**Village of Hobart**

**MEETING NOTICE – SITE REVIEW COMMITTEE**

**5. DISCUSSION AND ACTION - New 2,760 square foot commercial building and associated site improvements (Cyrus Dr., Portion of HB-194) (Page 4)**

**6. DISCUSSION AND ACTION - New 2,950 square foot Clubhouse Building and a 784 Square Foot Mail Room/Garage and associated site improvements (Lear Ln., Portion of HB-L159-2) (Page 21)**

**Site Plan**

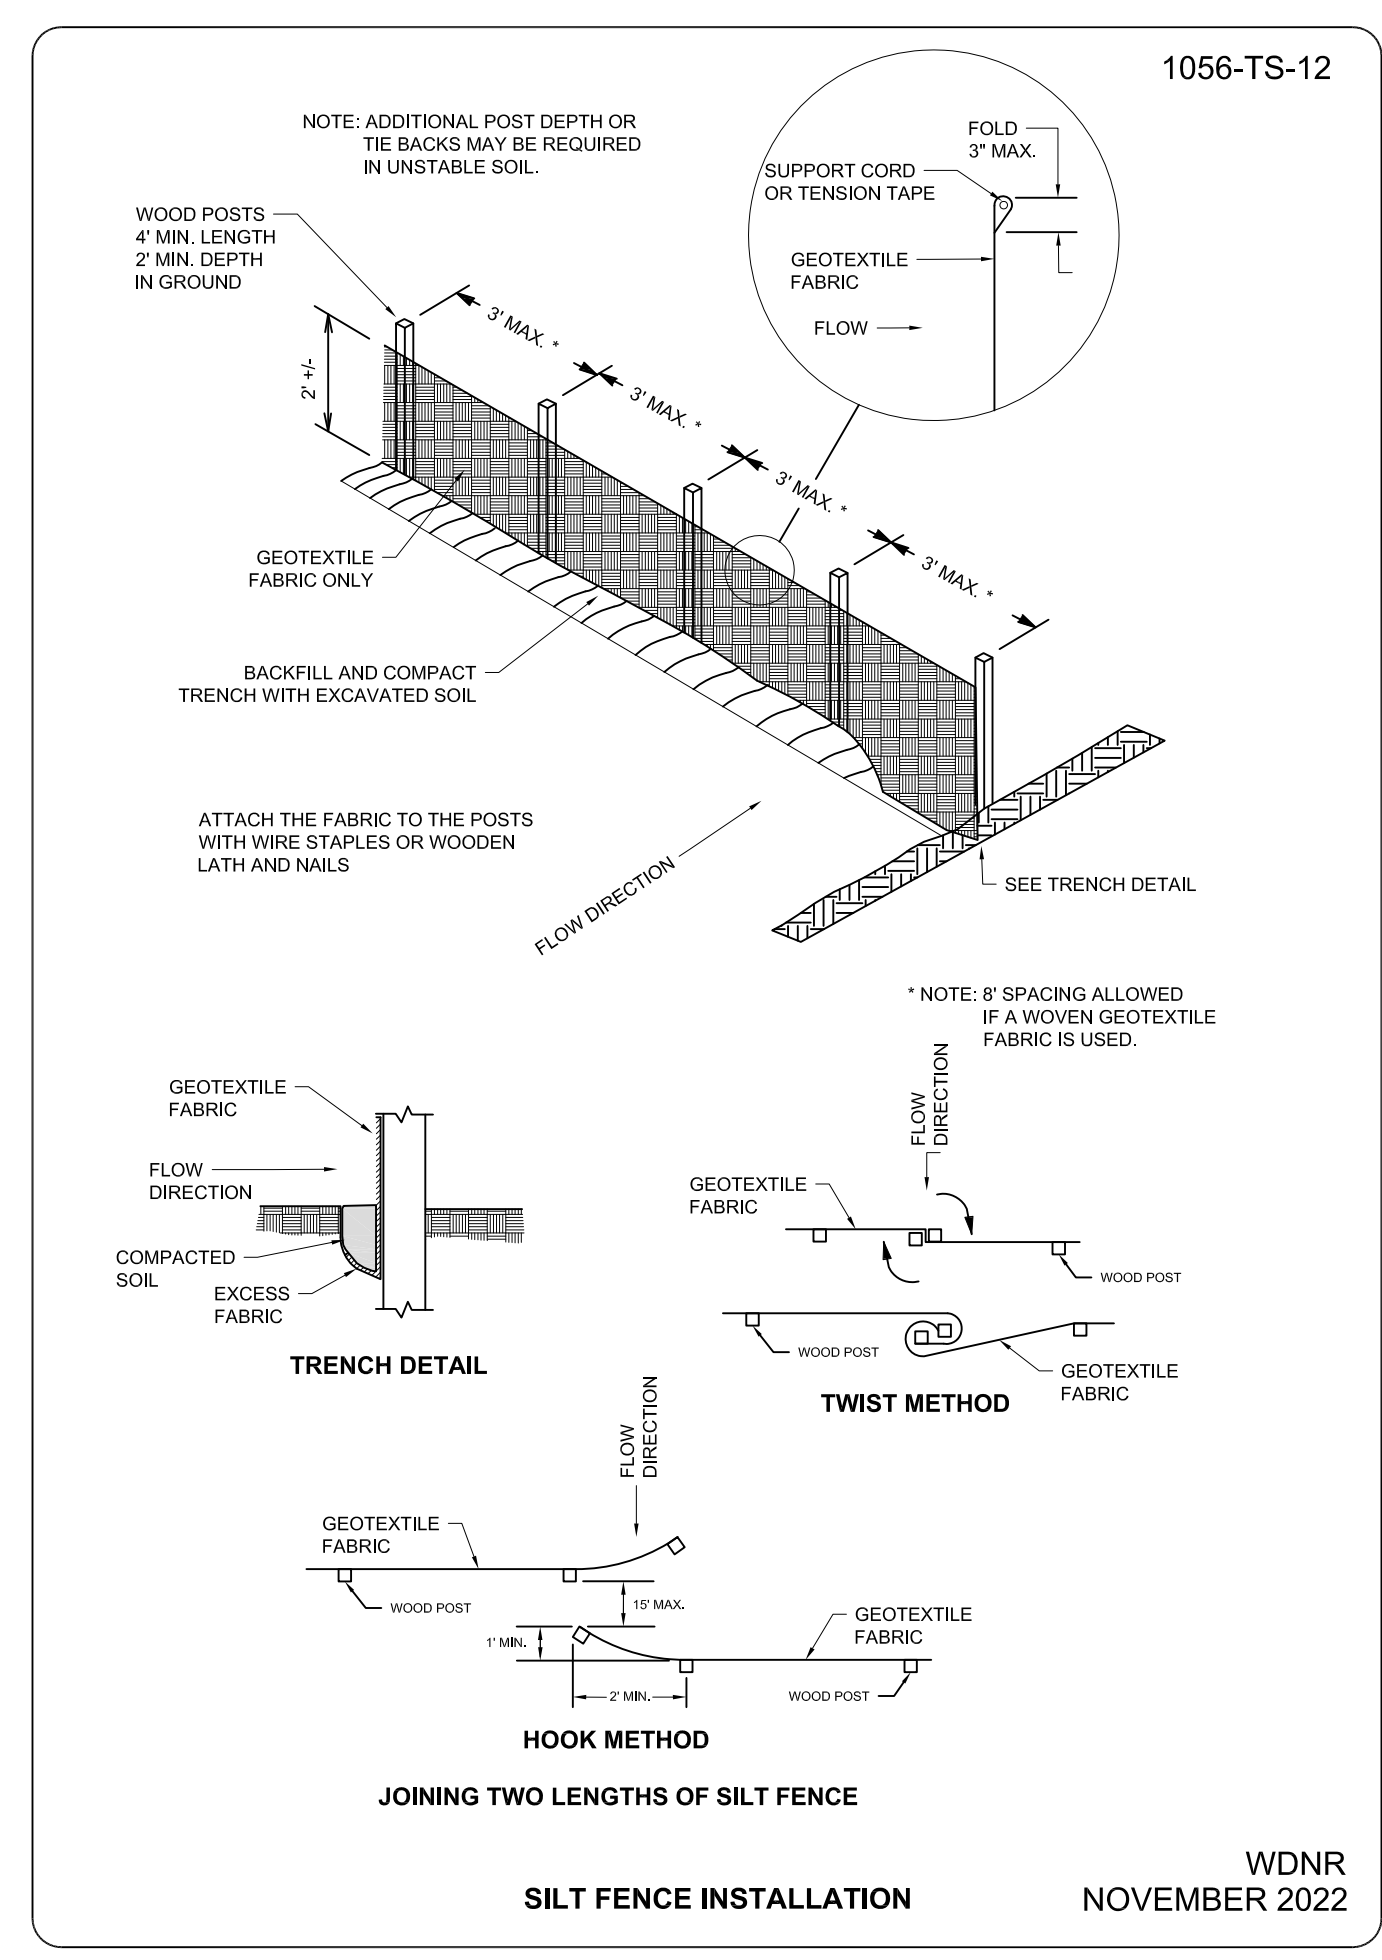
- D. **Parking:** Although no stalls (other than the one ADA stall) is illustrated on the site plan, a minimum of 3 spaces are required per code of 1 stall per 1,000 square feet of building area or for every two employees, whichever constitutes the greater number of stalls.

SIET LAYOUT  
ARVADA CLUBHOUSE  
File: M-21003 Clubhouse Area 100923.dwg

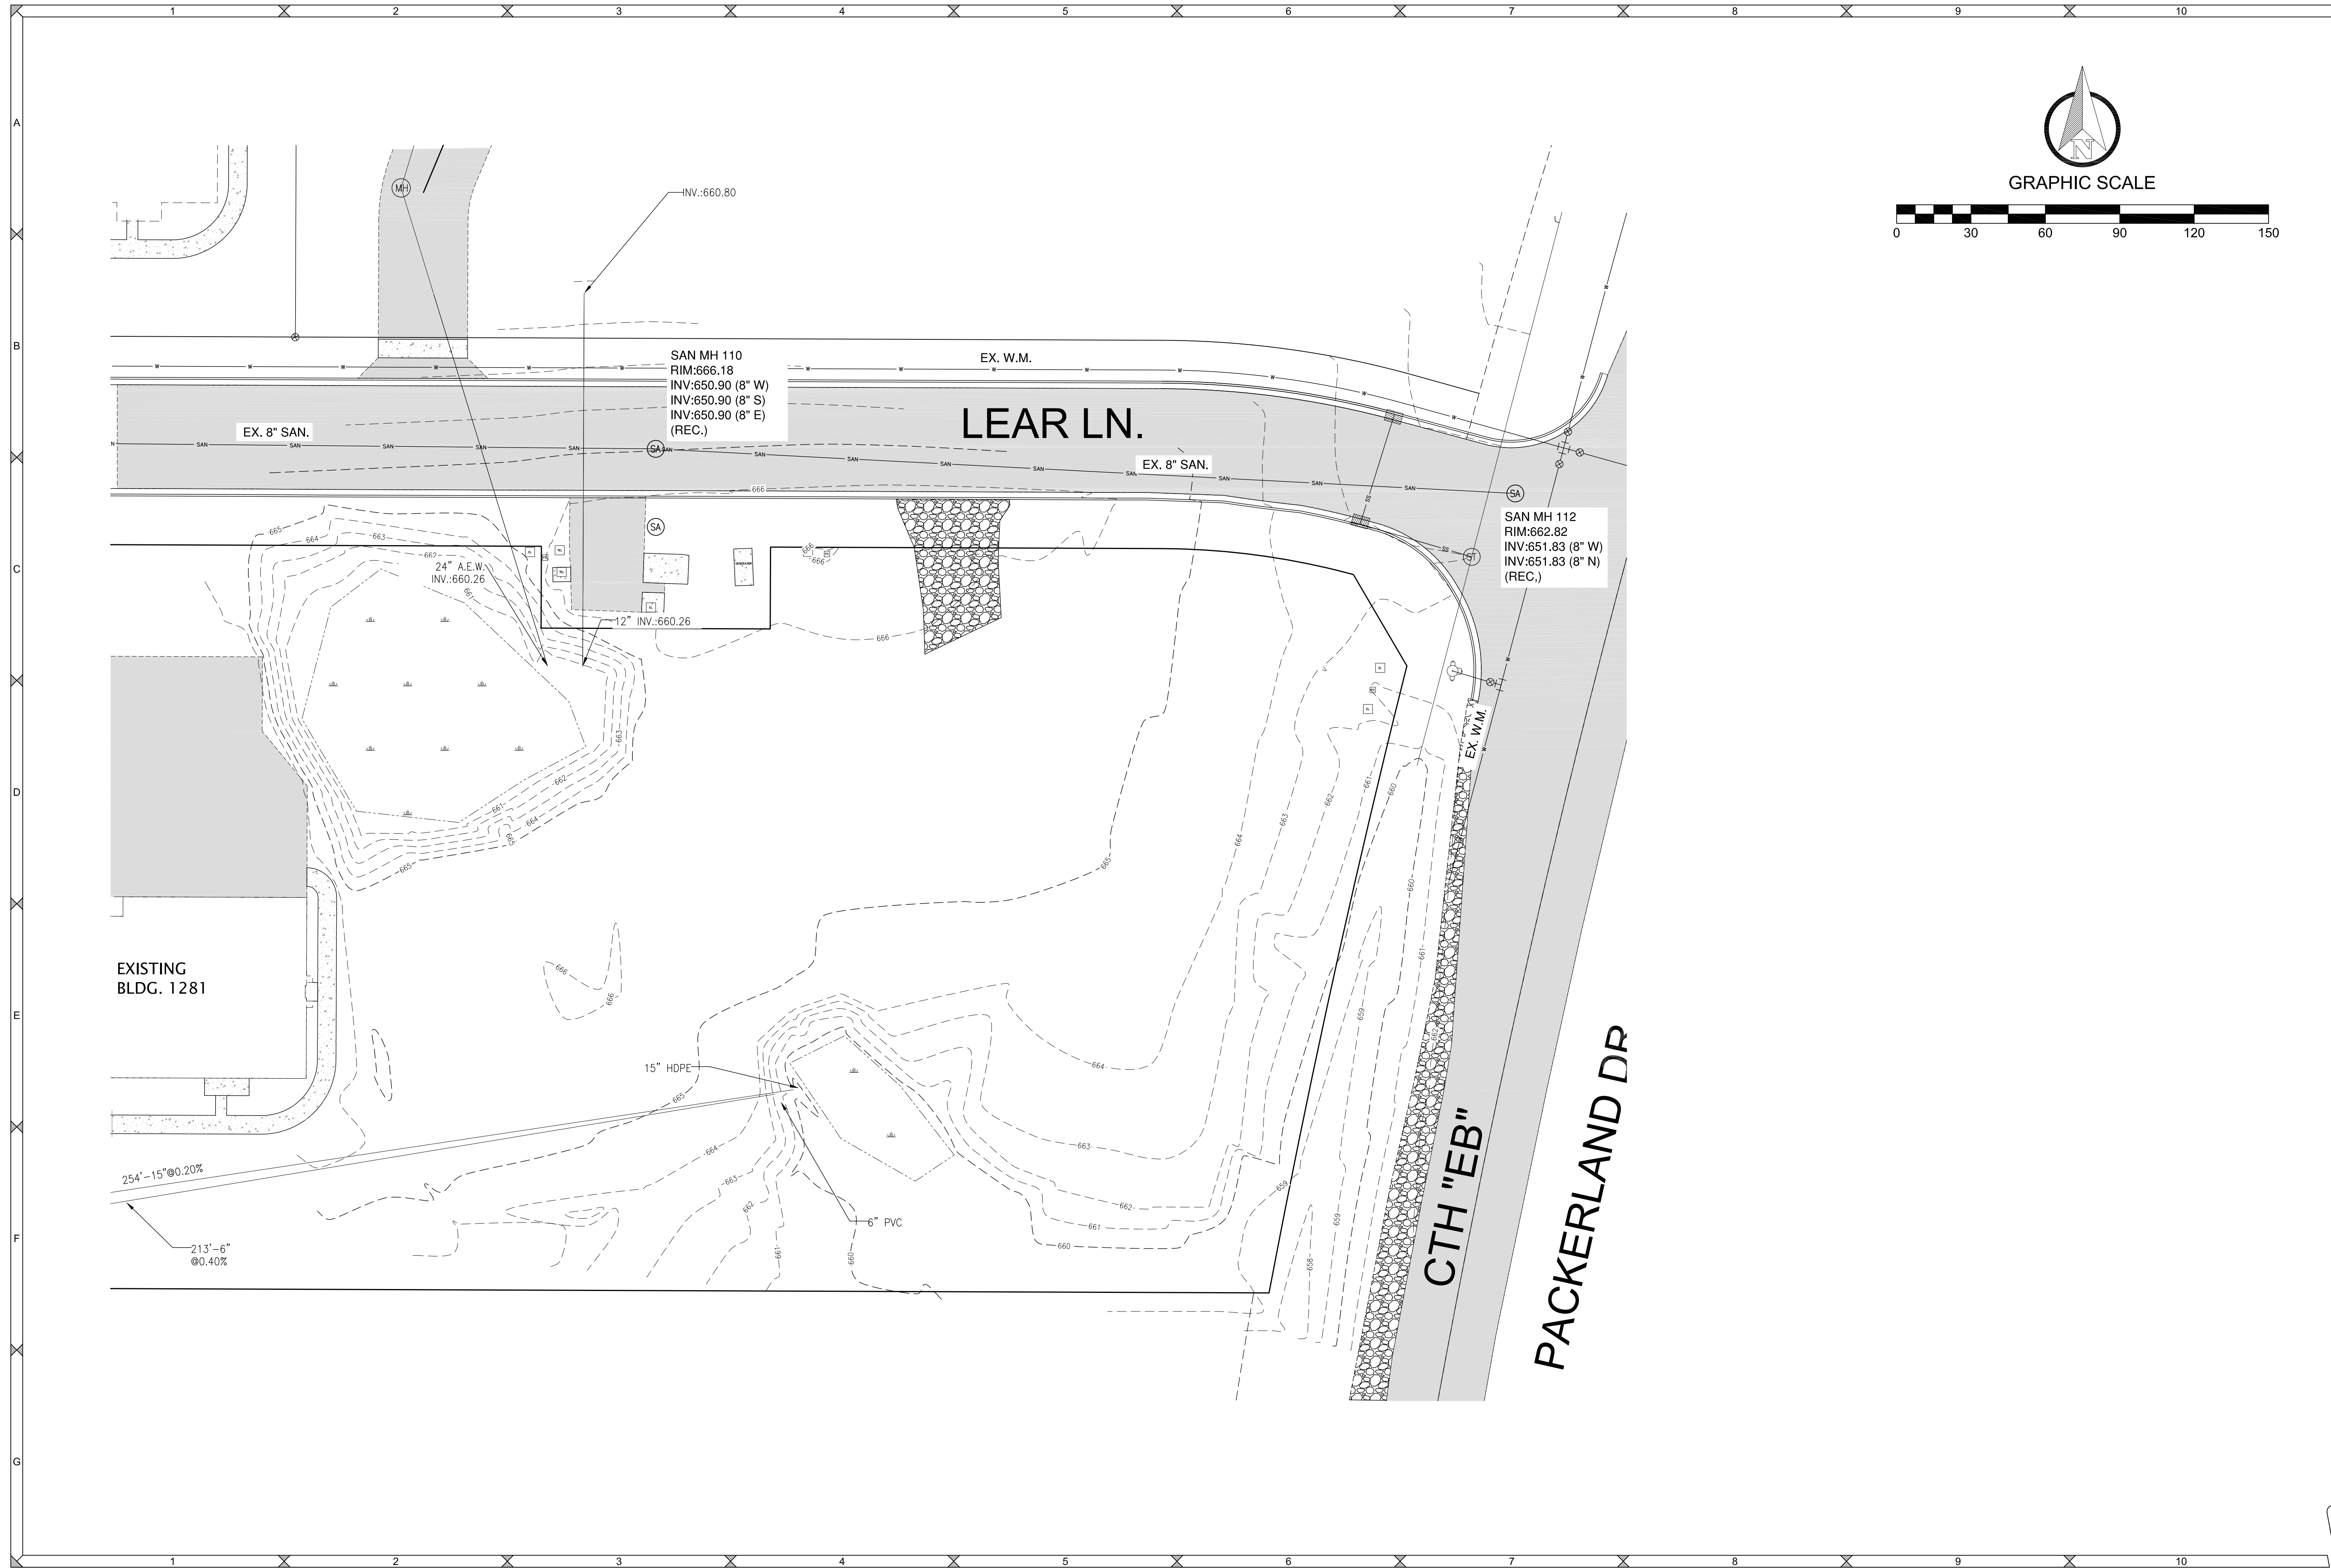
- A. **Zoning:** PDD#2: Orlando / Packerland Planned Development District
- B. **Green Space:** 53.8% green space proposed.
- C. **Setbacks:** Front setback along Lear Ln. – 99’ (30’ minimum), 30’ to east property line (Packerland Dr.) (30’ minimum), and 46’ to south property line (rear of building) (25’ minimum). All comply with zoning requirements.

- D. **Parking:** 28 stalls are proposed and based on an “office” type use, 10 stalls are required.
- E. **Fire Dept. (and Police Dept.):** The plans are currently being reviewed by the Police Department and Fire Department and any conditions or concerns will be brought to the committee meeting.
